**UNITED NUCLEAR  
CORPORATION**

SUBJECT: SNM-777 LICENSE FOR FUELS RECOVERY PLANT,  
WOOD RIVER JUNCTION, RHODE ISLAND

WE ARE RESPECTFULLY REQUESTING AMENDMENT OF SNM-777 TO INCLUDE A REVISION TO THE STORAGE ARRAY DESCRIBED IN PARAGRAPH 504.3 OF "GENERAL INFORMATION AND PROCEDURES APPLICABLE TO THE HANDLING OF SPECIAL NUCLEAR MATERIAL". THE ONLY CHANGE IN THE ARRAY IS THE HORIZONTAL SPACING OF INDIVIDUAL CONTAINERS---THE ORIGINAL SPACING OF 32" CENTER TO CENTER BEING REDUCED TO 16" CENTER TO CENTER.

INSIDE STORAGE SHELVES.  
REF. PARAGRAPH 504.3

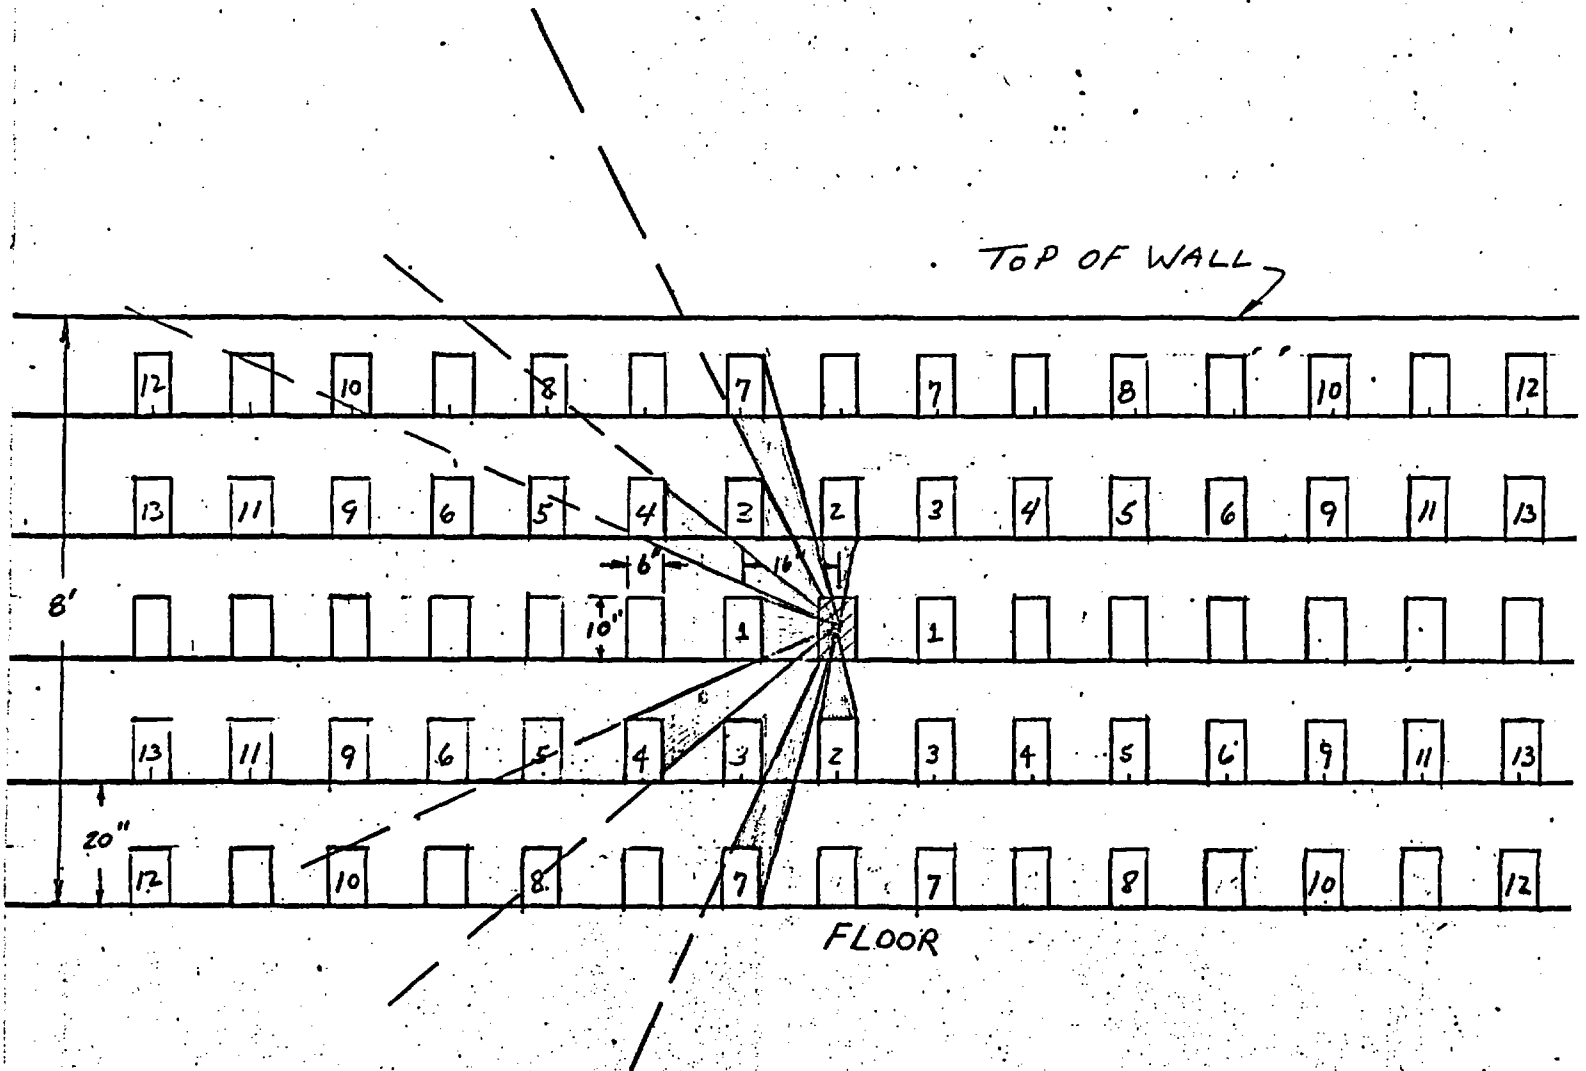
A REVISED SKETCH OF THE ARRAY AND SOLID ANGLE CALCULATIONS ARE SUBMITTED HERewith FOR YOUR REVIEW AND APPROVAL. YOU WILL NOTE THAT THE SOLID ANGLE CALCULATED FOR THE ENTIRE ARRAY IS 2.56 STERADIANS. THIS INCLUDES THE SOLID ANGLE SUBTENDED AT THE CENTRAL UNIT BY ALL THE NUMBERED UNITS ON THE SKETCH. HOWEVER, ONLY UNITS NUMBERED 1, 2, 3, 4 AND 7 ARE "VISIBLE" TO THE CENTRAL UNIT. THE SOLID ANGLE IN THIS CASE IS ONLY 2.10 STERADIANS. AS DESCRIBED IN PARAGRAPH 504.3, THE SAFE SOLID ANGLE IS 3.0 STERADIANS.

SOLID ANGLE SUBTENDED AT CENTER BOTTLE BY:

GRAND TOTAL 2.556

TOTAL FOR BOTTLES 1, 2, 3, 4, 7 IS 2.104 STERADIANS.
